PLANNING RESPONSES
SUNLIGHT HOUSE
APRIL 2023

EXTERNAL ALTERATIONS

INTERNAL ALTERATIONS

Facing | example of system installed on Grade I listed church roof

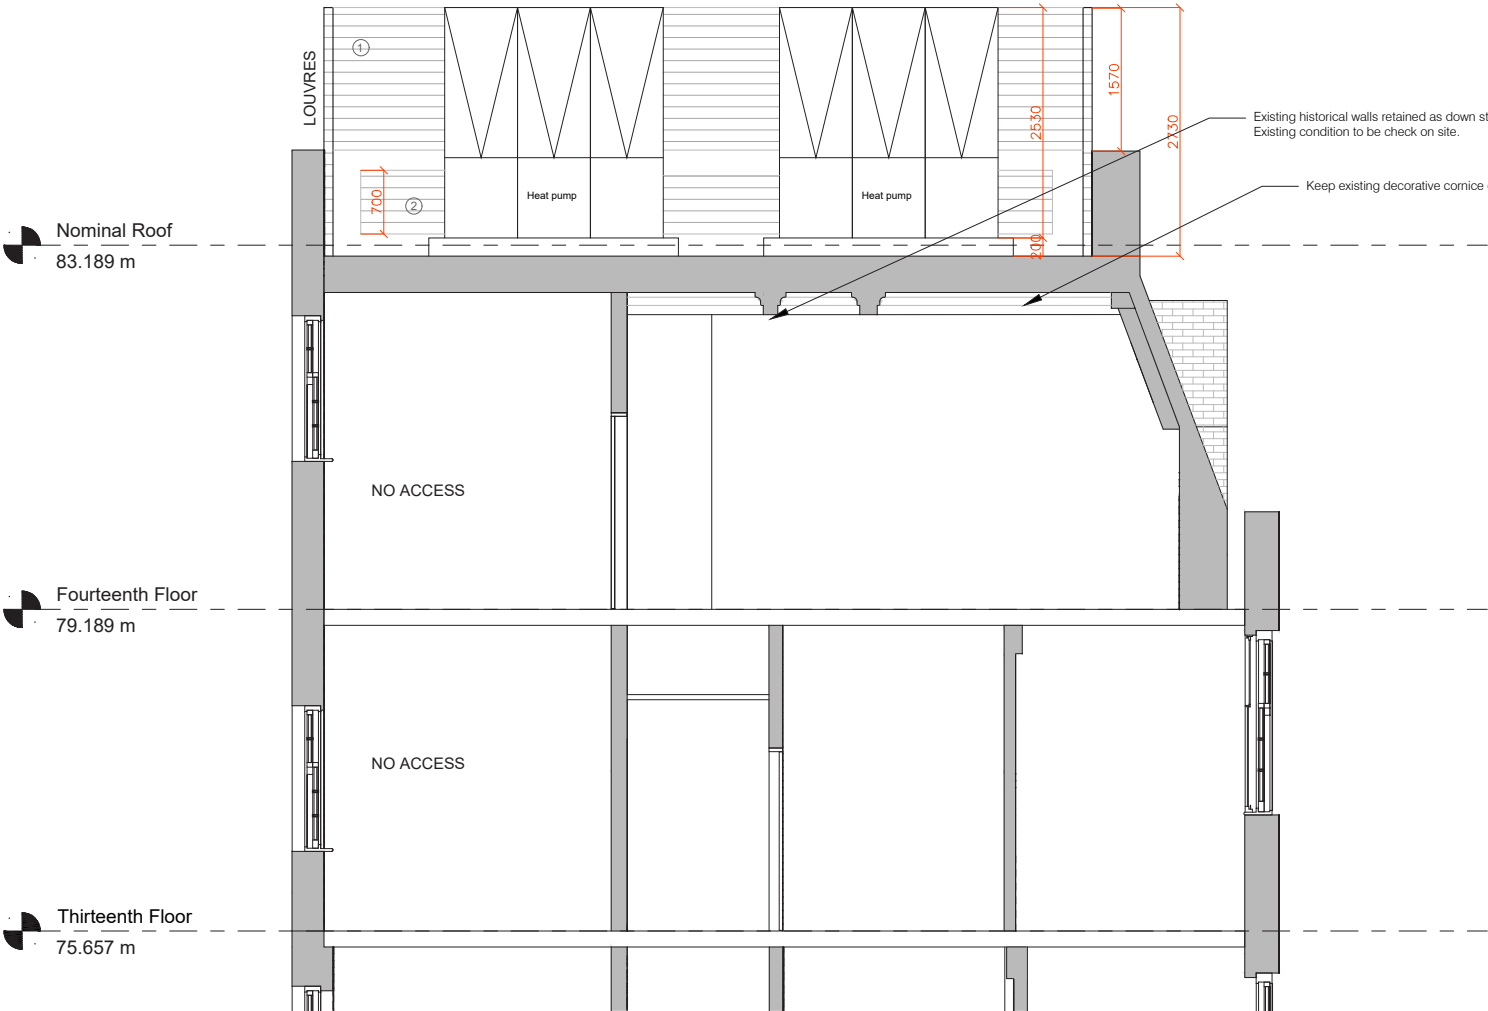
The solar panels to the Quay Street elevation should be removed. We will only support them on the internal roof slopes.

- projection is limited, particularly in this case, to around 200mm
- the tile hanger system is the least invasive in material terms but gives the same outward aesthetic
- it ensures the maximum amount of material is maintained on site

8. PLANT ENCLOSURE

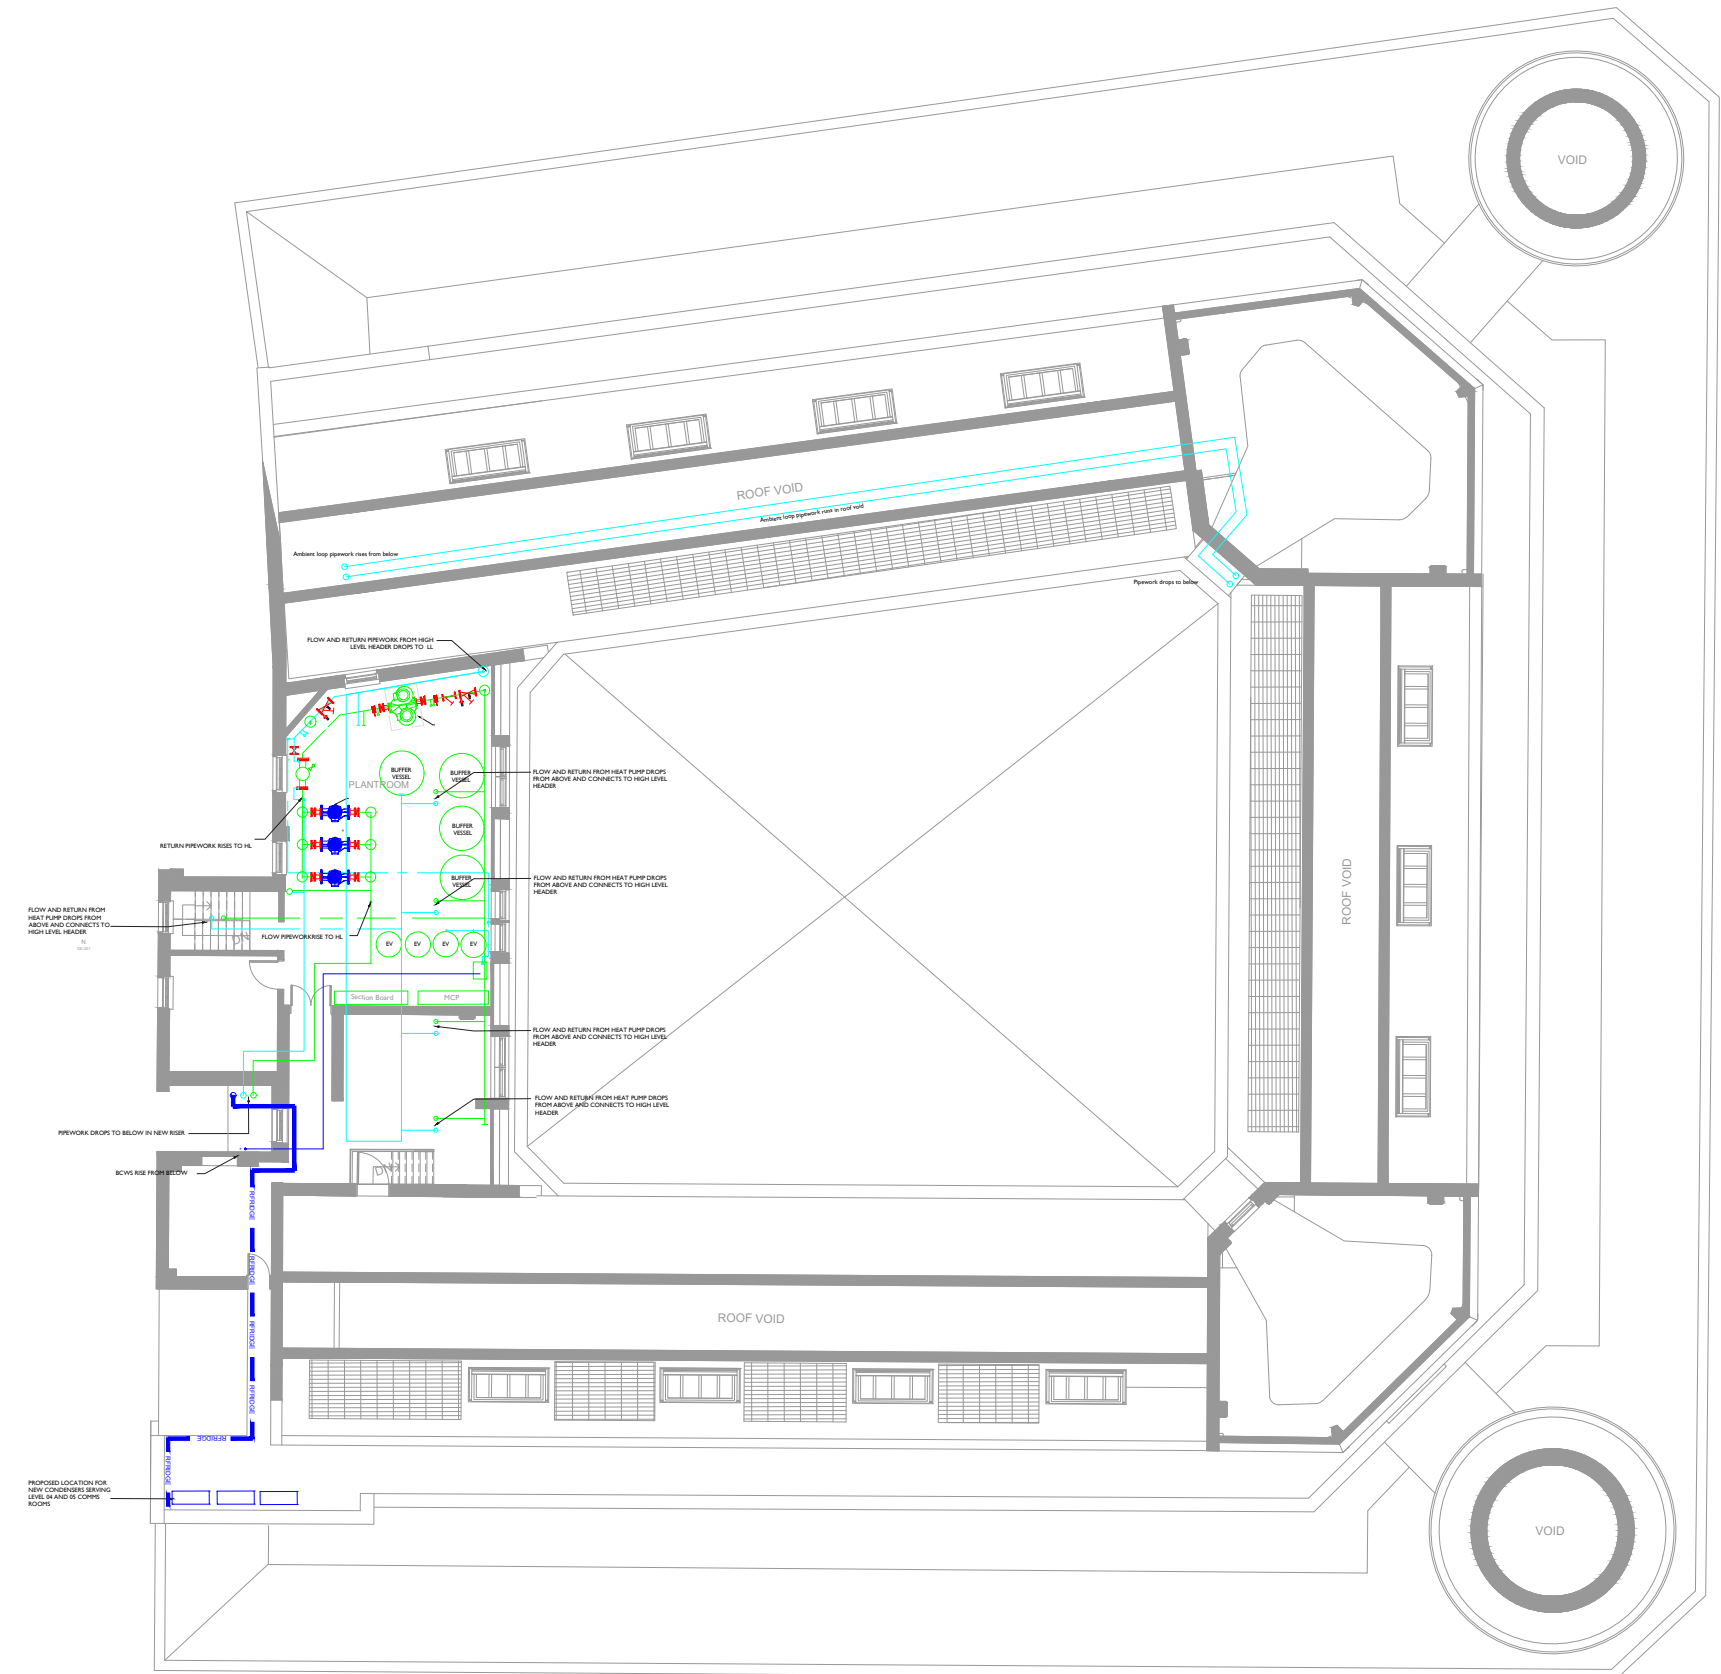
Further details on the appearance and finish of the louvre enclosure to the heat pump should be provided together with details of the cabling and additional M&E services (connecting to the pvs and heat pumps).

Further details are provided to support this. The acoustic report confirms no attenuation is required however we are proposing the screen for visible masking of the Air Source Heat Pumps. A reference image is below. Our preference is for a white finish, to continue the parapet below.

The existing connection routes from the equipment already in this location is to be re-used. The route uses the pitch of the roof at level 13 to cross the building to risers associated within the eastern cores while dropping straight down into the western risers.
